Exhibit I  
BRODIE OAKS REDEVELOPMENT  
WATER QUALITY AND DRAINAGE

PUD CASE #: CD-2020-0002-BRODIE OAKS REDEVELOPMENT

### COMMENT REPORT

PROJECT NAME: Brodie Oaks Redevelopment

## BRODIE OAKS REDEVELOPMENT PHASING PLAN

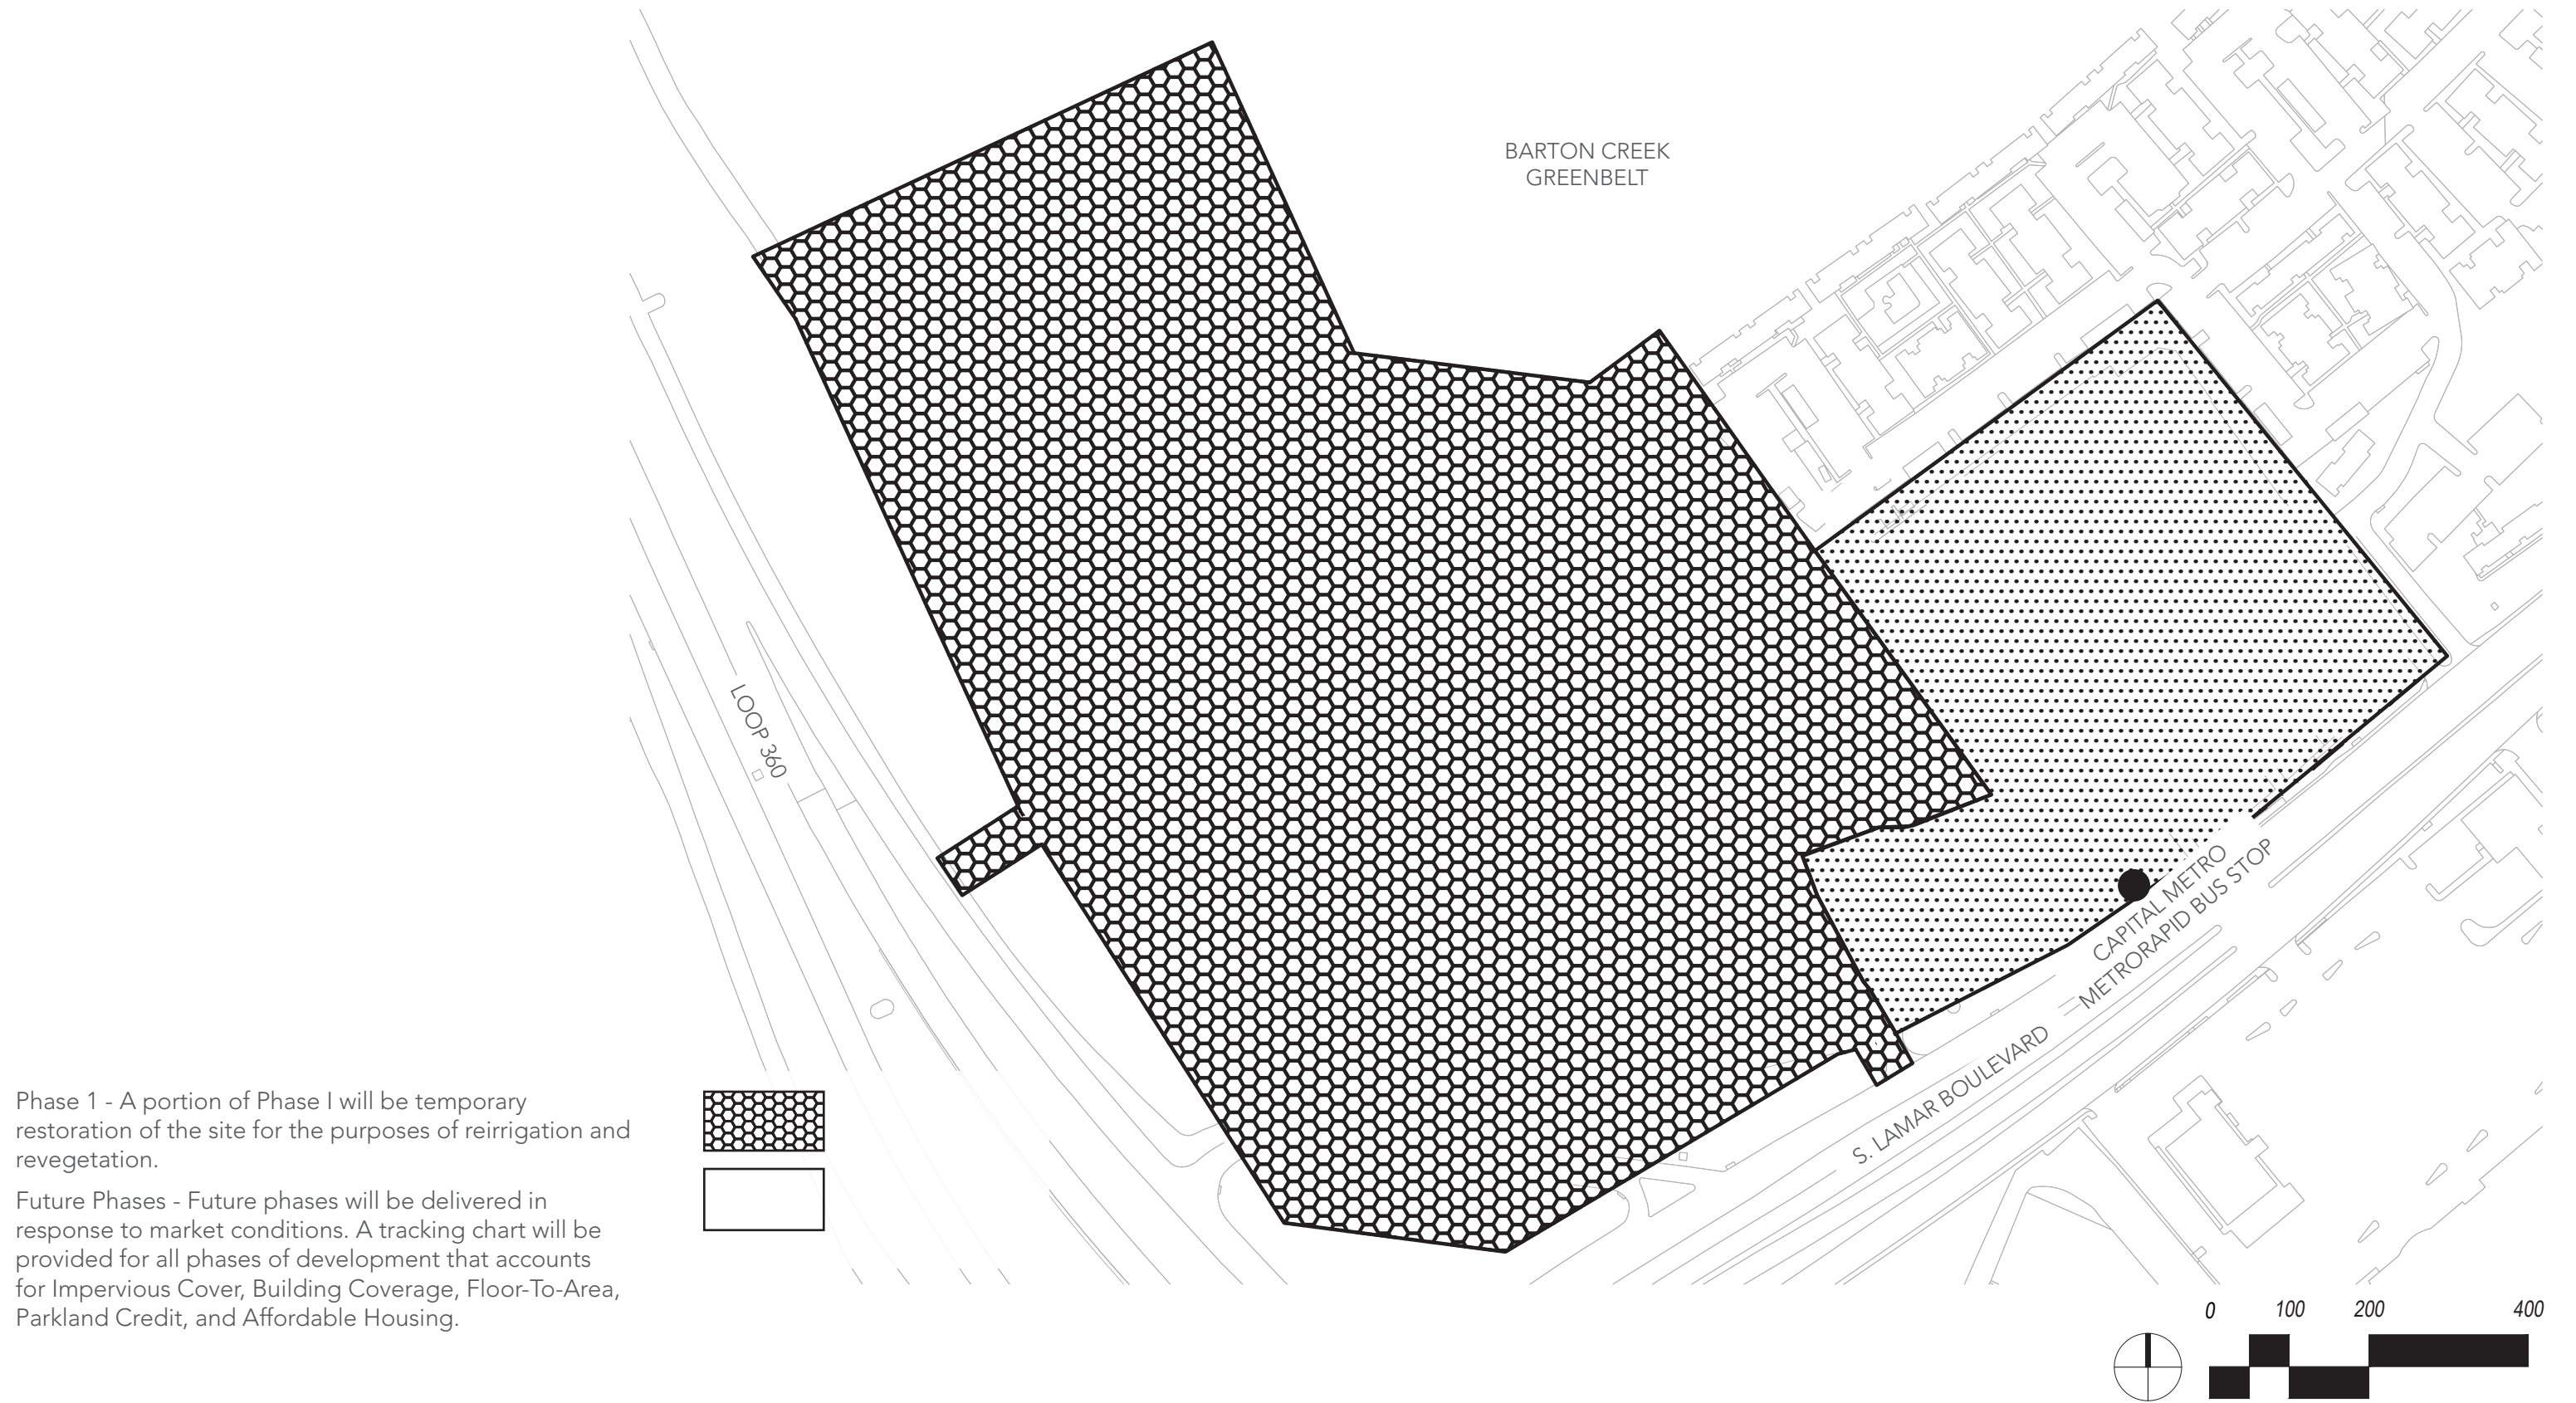
2. ***Phasing.*** The proposed phasing plan is somewhat vague; however, there appears to be two areas where SOS water quality ponds are planned. To ensure that the non-degradation requirement of the SOS Ordinance is met for each new building, the ponds to which that building would drain should be completed and operational before any certificate of occupancy is issued for such building.

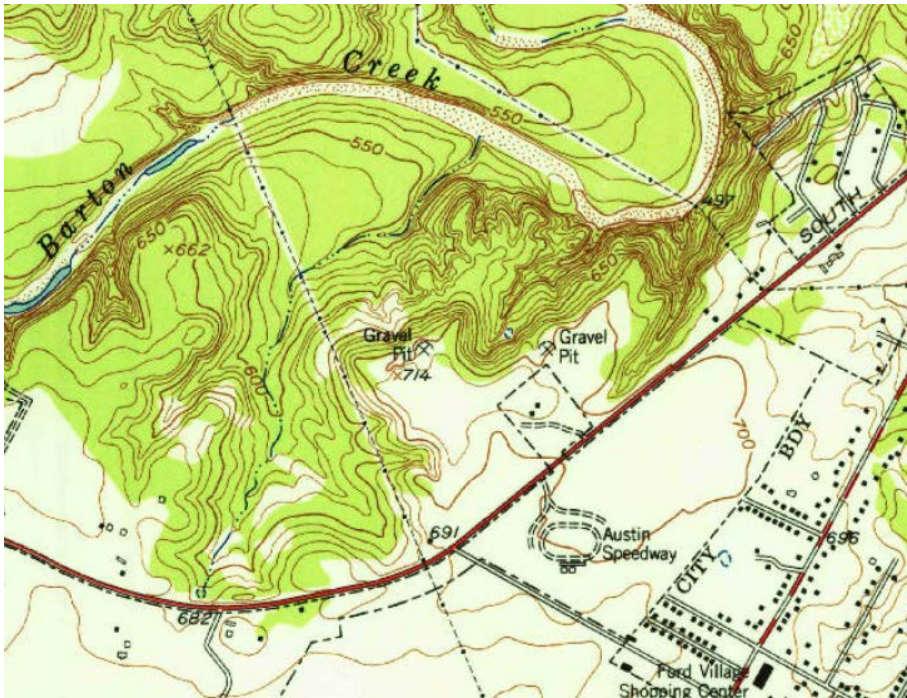
- EV12. 25-8-341/25-8-342: In addition to comments EV 10 and EV 11, according to aerial imagery as far back as 1955 (see below), the site was a gravel pit for several decades prior to the existing development. Historically, it has been the interpretation of Staff that grading in excess of four feet to restore pre-development grades is an acceptable exemption to City Code 25-8-341/342. Remove this proposed code modification from the proposed PUD application.

Figure 1. 1972 – cave passage survey

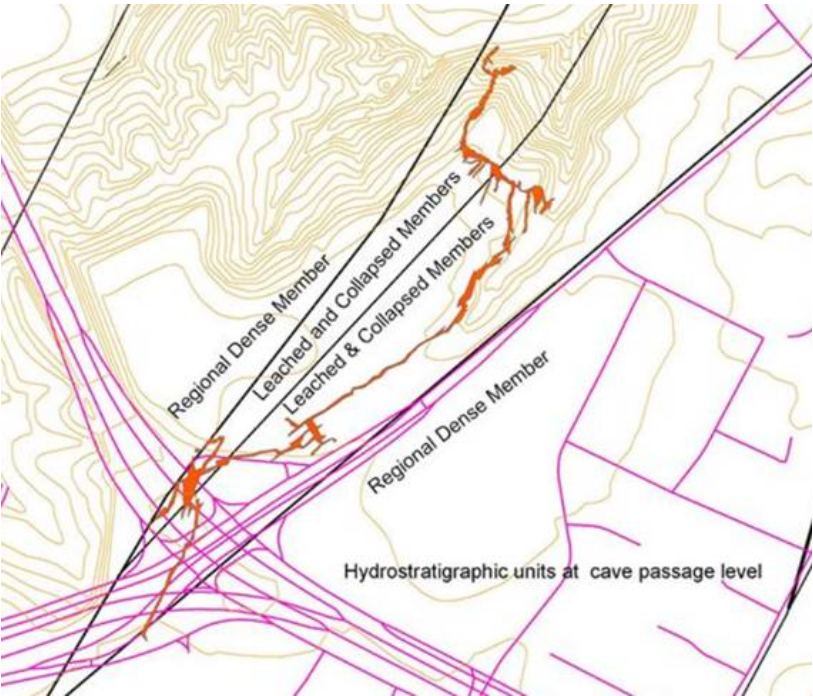
- HG 1. At this time, site specific information is unavailable or inaccurate regarding vegetation, areas of steep slope, or other environmental features such as bluffs, springs, canyon rimrock, caves, sinkholes, and wetlands. For example, the Environmental Resource Inventory Report prepared does not identify Airmans Cave, which is a cave listed on the City of Austin's 10A Permit. The cave passage is located beneath the site and is within 150-ft. The approximate location of cave passage is shown in map view below (Figure 1). Please be advised that according to Nico Hauwert, the 1972 survey map shown in red was not done with inclination measurements, so the actual horizontal distances are shorter than shown on the map, and one cannot determine rise in the cave passage from the entrance from the 1972 map. In 1995/1996, Mark Sanders, Jim Kennedy and Nico Hauwert remapped 2/3 of the Cave. The profile attached shows the cave depth relative to the surface for the first 2/3 of the cave were surveyed (Figure 2). The attached map compares their survey (green dots) to the red scan of the 1972 cave map (Figure 3). Please update the ERI report

to include Airmans Cave and any protective measures proposed to preserve the cave itself and the water quality and water quality in the cave.
